DA (AMENDED)

67 PP
67 Pacific Parade DEE WHY NSW 2099

DRAWING TITLE
SITE CONTEXT PLANS

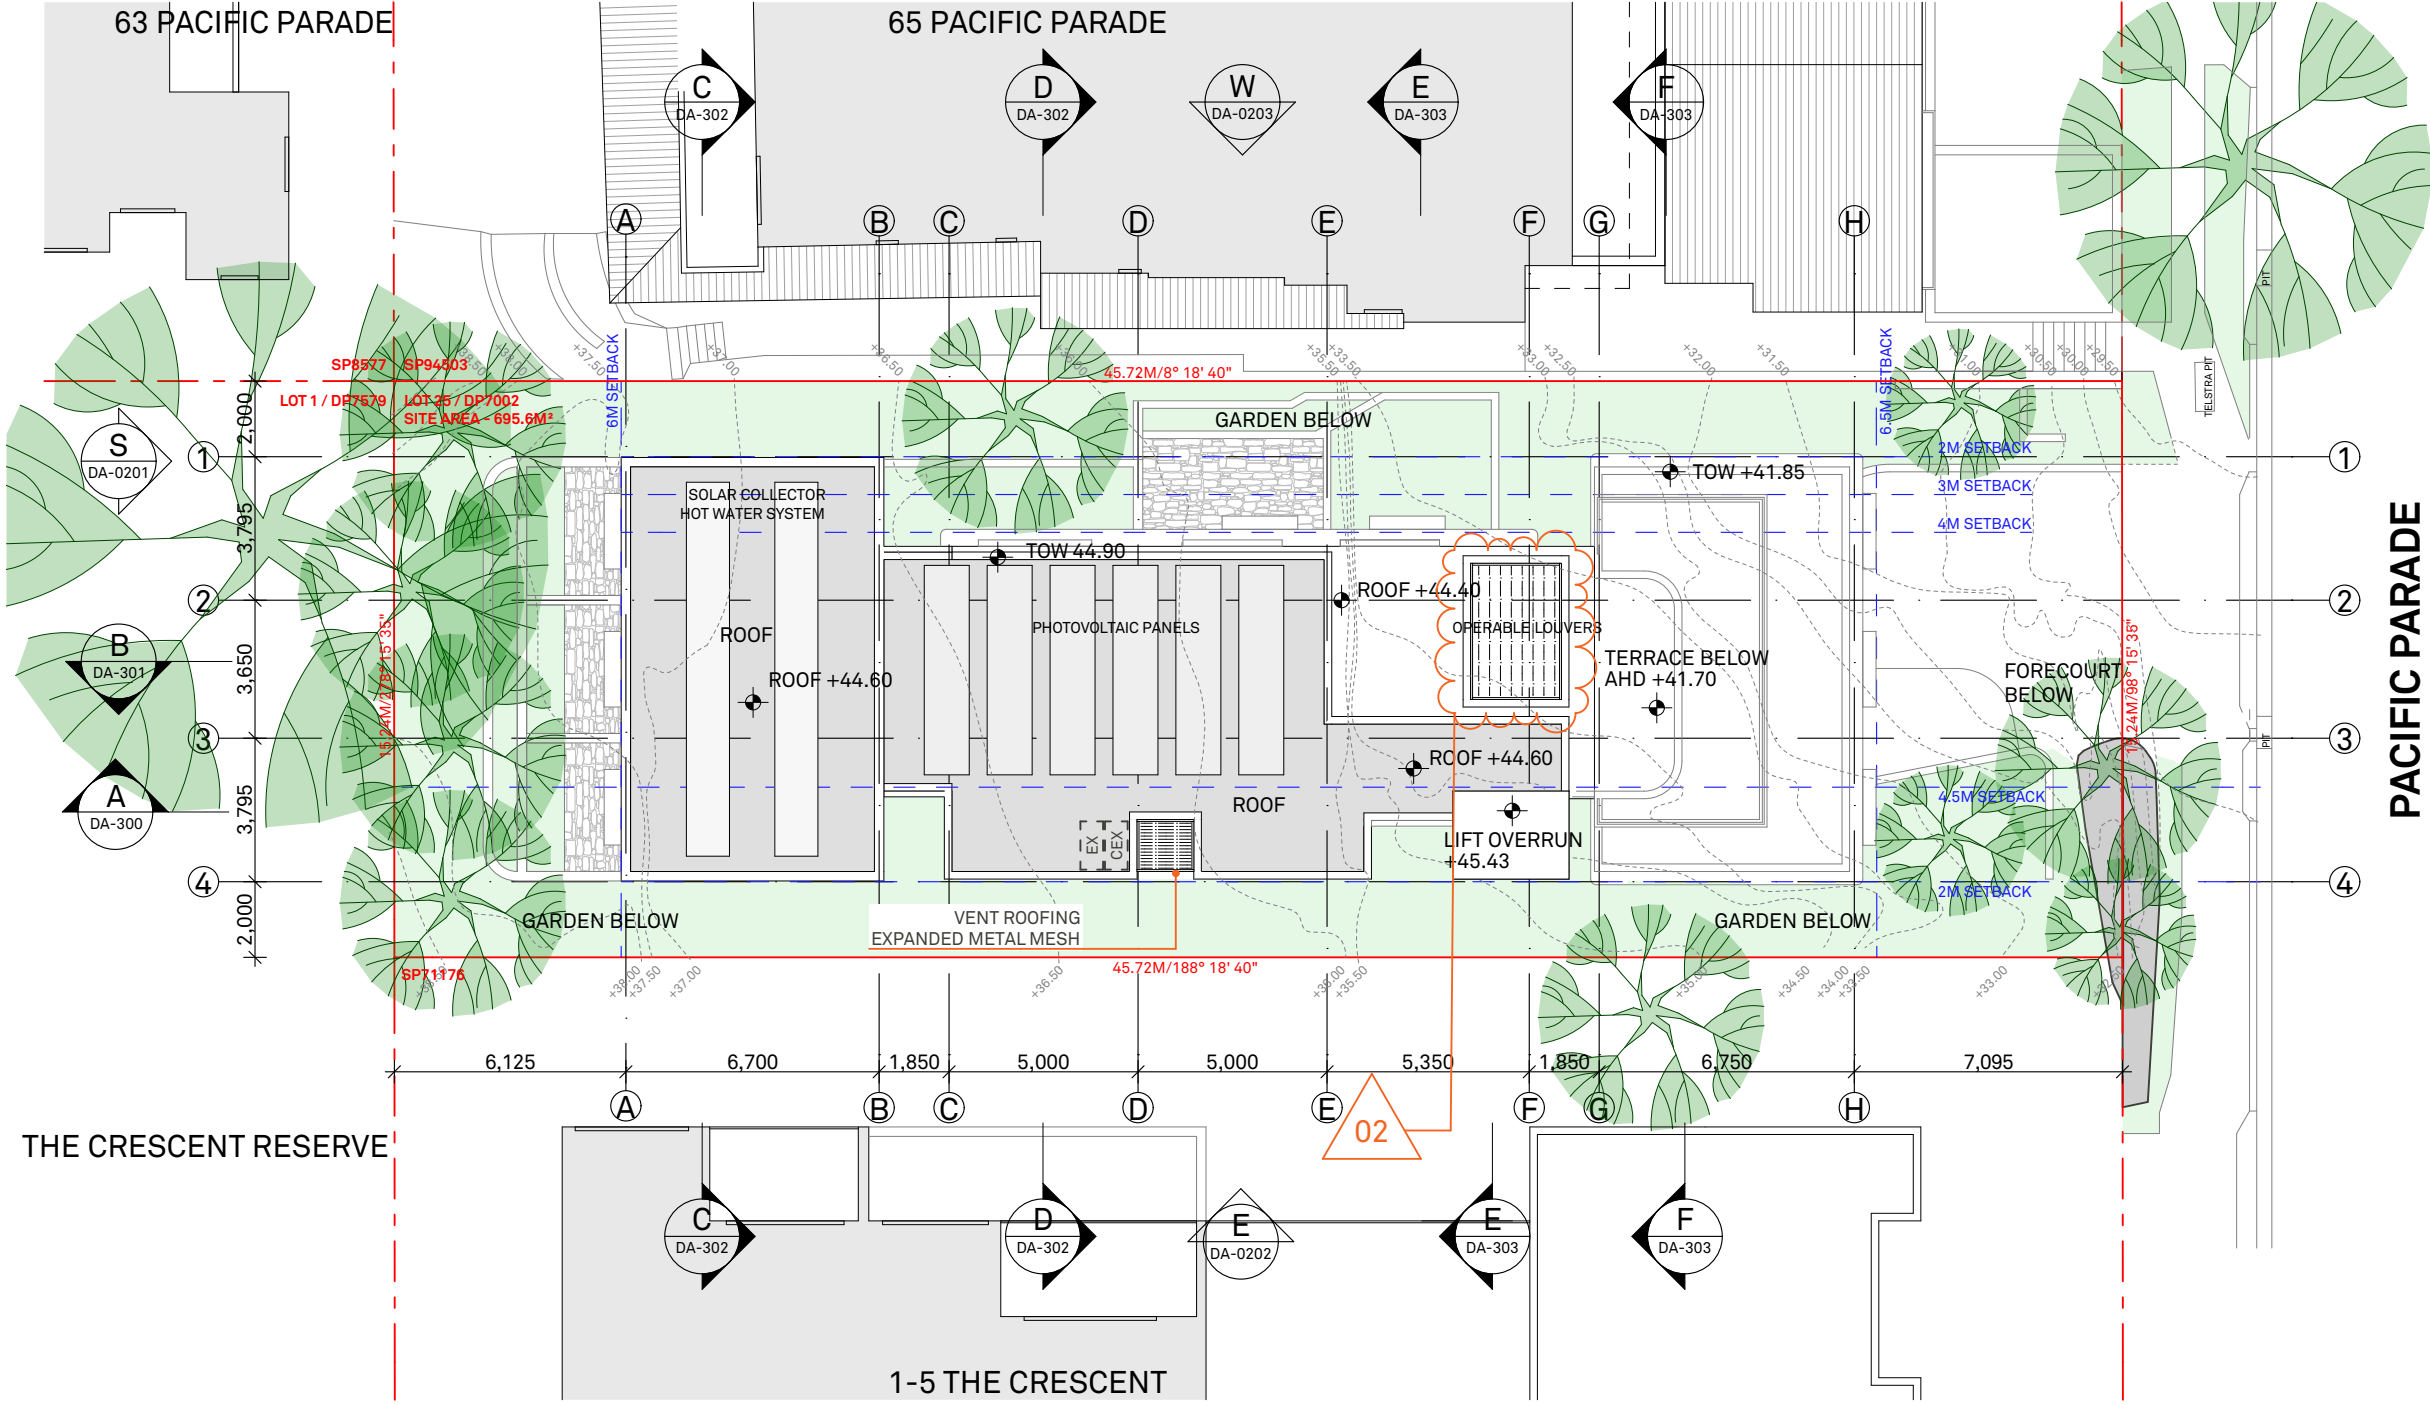
CONVERT ROOMS L301-303 FROM TYPE E TO TYPE B (REMOVE LOFT BEDROOMS ABOVE); REMOVE 2x ROOMS; REPLACE WITH LARGER COMMON ROOM; REDUCE AREA OF COMMUNAL OPEN SPACE; PROVIDE PRIVACY SCREENS TO COS

1 NORTH ELEVATION
1:200

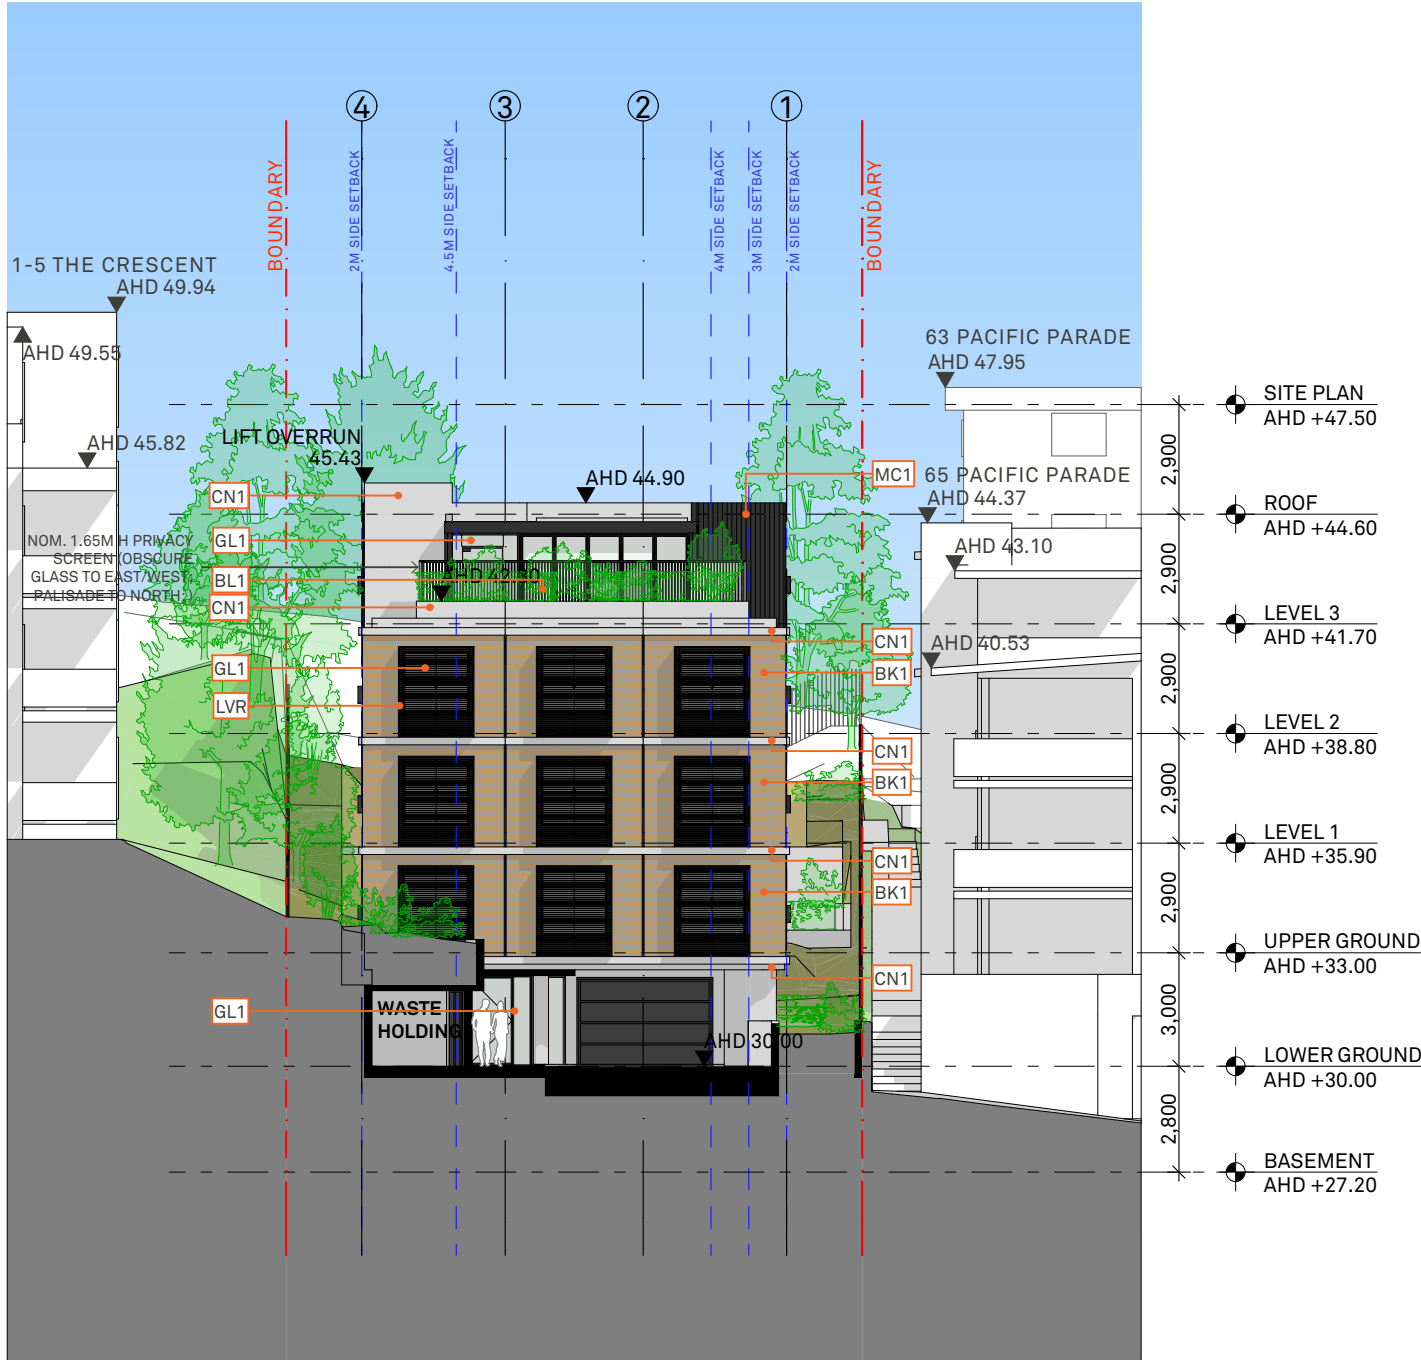
- 01 DELETE LOFT BEDROOMS; REPLACE TYPE E ROOM WITH TYPE B
- 02 REPLACE GARBAGE STORE WITH HOLDING AREA; WIDEN DRIVEWAY; REDUCE GARAGE DOOR WIDTH; INCREASE LANDSCAPED AREA AT THE NW BOUNDARY; INCREASE SOIL DEPTH ABOVE WASTE ROOMS.
- 03 PRIVACY SCREEN TO COMMUNAL OPEN SPACE

1 SOUTH ELEVATION
1:200

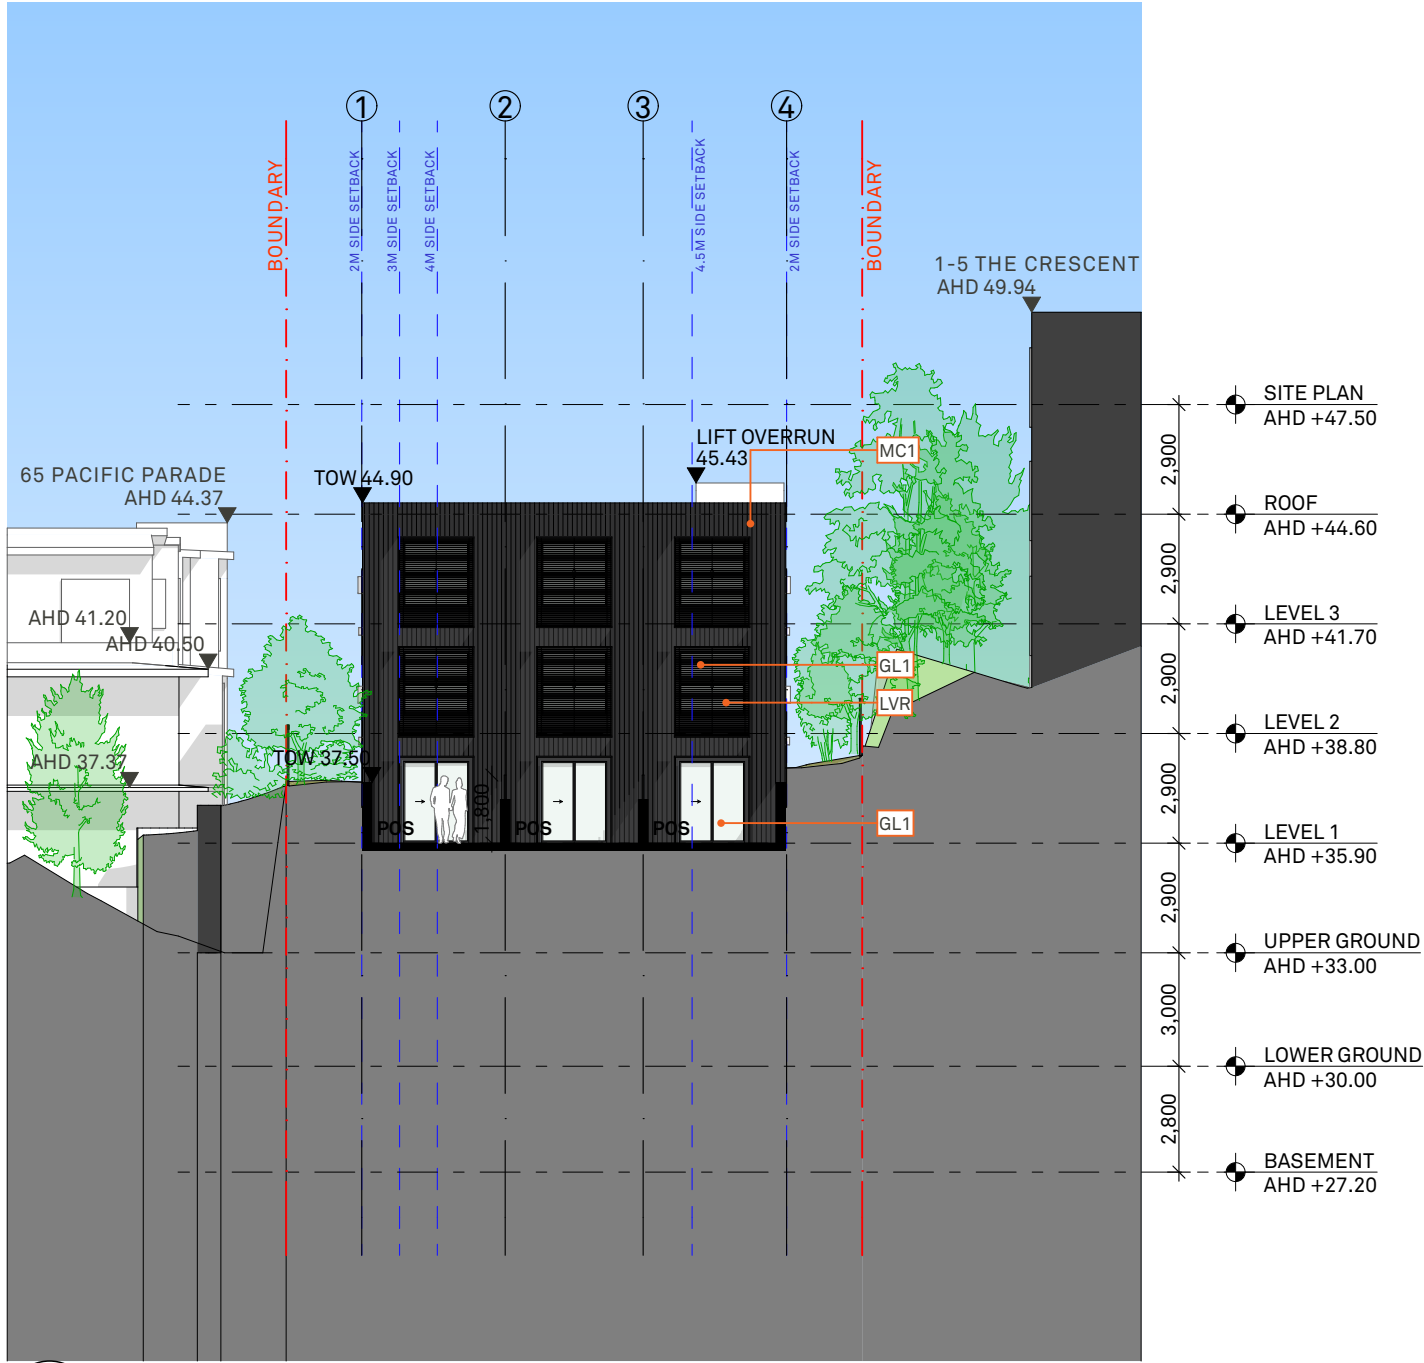
- 01 DELETE LOFT BEDROOMS; REPLACE TYPE E ROOM WITH TYPE B
- 02 REPLACE COMMON ROOM AND COMMUNAL OPEN SPACE WITH 3x ROOMS AND PRIVATE OPEN SPACE

WEST ELEVATION
1:200

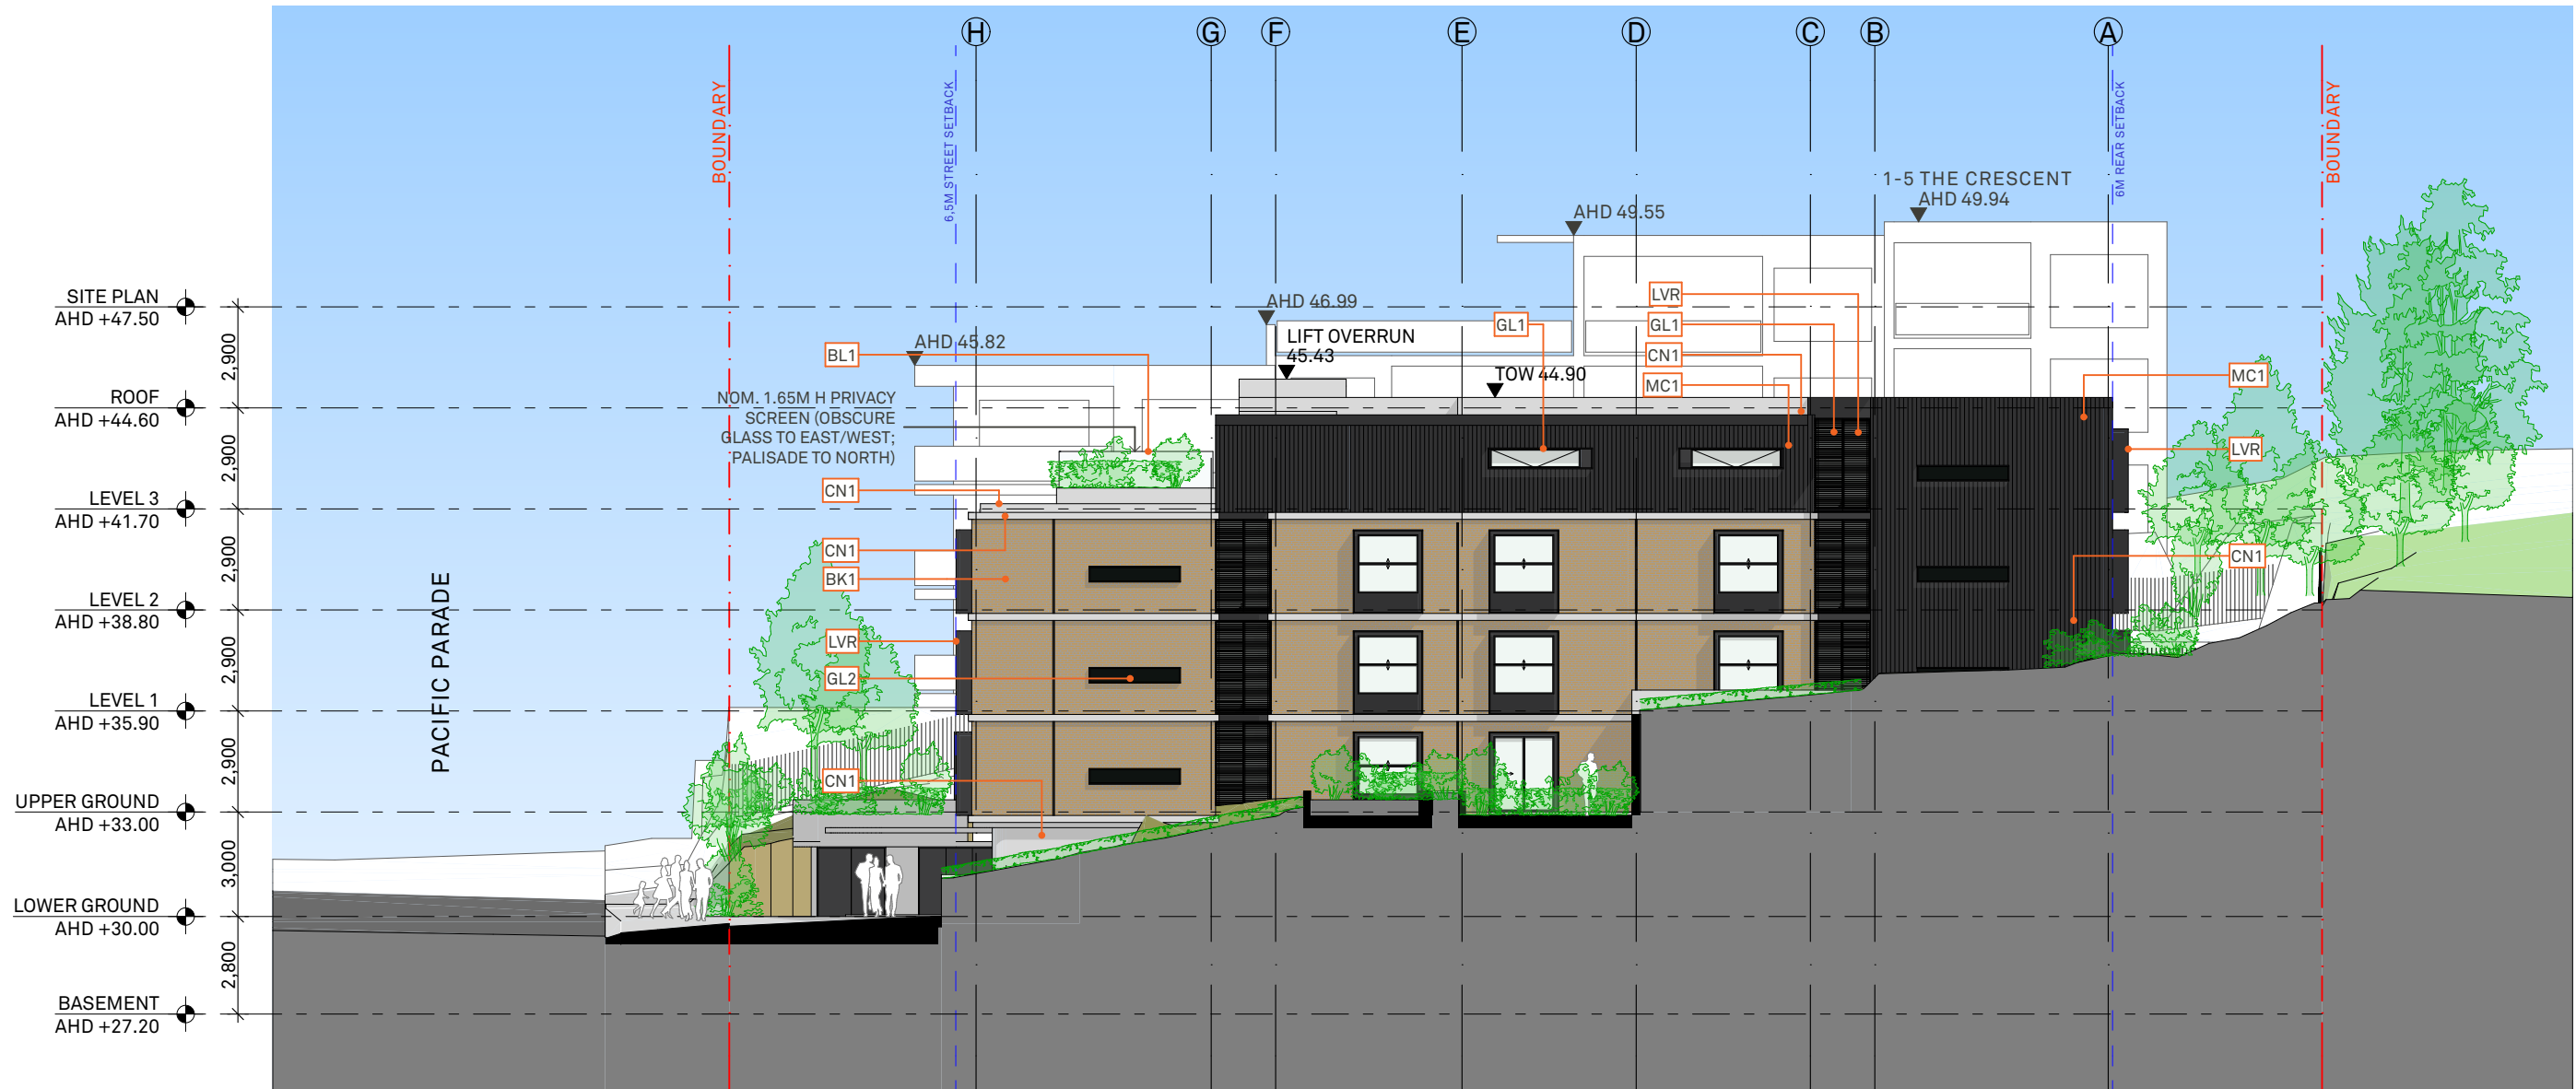
- 01 DELETE LOFT BEDROOMS; REPLACE TYPE E ROOM WITH TYPE B; REMOVE 2x ROOMS IN FAVOUR OF ENLARGED COMMON ROOM AND COMMUNAL OPEN SPACE
- 02 REMOVE BASEMENT FLOOR, LOWER LEVEL COMMON ROOM (LWR GRD); INSTALL CAR STACKERS
- 03 REDUCE AREA OF COMMUNAL OPEN SPACE; PRIVACY SCREEN TO COMMUNAL OPEN SPACE
